### THE CITY OF PHENIX CITY PLANNING COMMISSION AGENDA TUESDAY, APRIL 9, 2019 5:15 PM EST

Staff Report No. 7

## MEMORANDUM

Waiver for Wynnbrook Subdivision

# MASTER DEVELOPMENT CONCEPT The Lands of

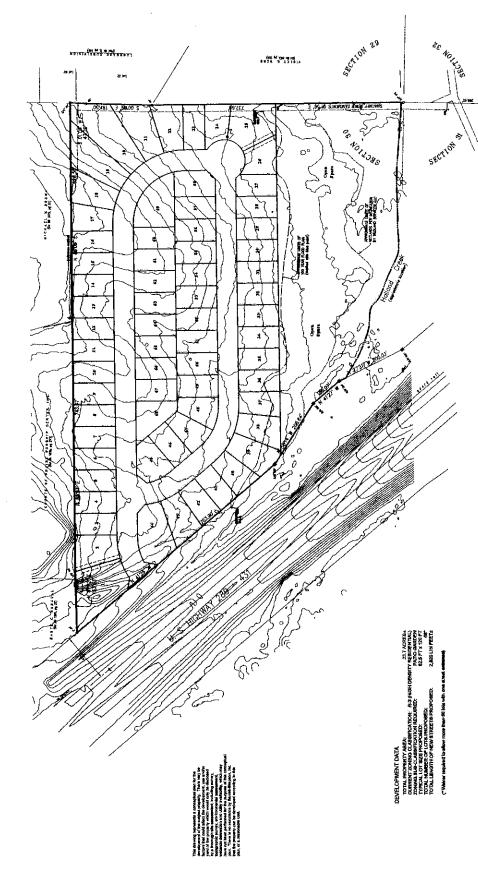
The submitted waiver for Wynnbrook Subdivision, which is a proposed 68 lot subdivision with one entrance/exit road, does not meet the requirements of Article IV, Section 2.A of the City of Phenix City Subdivision Regulations which states that subdivisions between 61 and 200 lots are required to construct two entrance/exit roads. Although information has been provided that ALDOT will not allow an additional entrance onto US Hwy 280, the developer could reduce the number of lots in the subdivision to 60 lots to meet the requirement. Also, the waiver form states that the request should be approved based on the fact that the subject property was purchased prior to the previously mentioned requirement being adopted into the Subdivision Regulations. It is my opinion that the developer should have considered that regulations are subject to change over time. The most current regulations govern at the time a property is developed, not at the time of purchase.
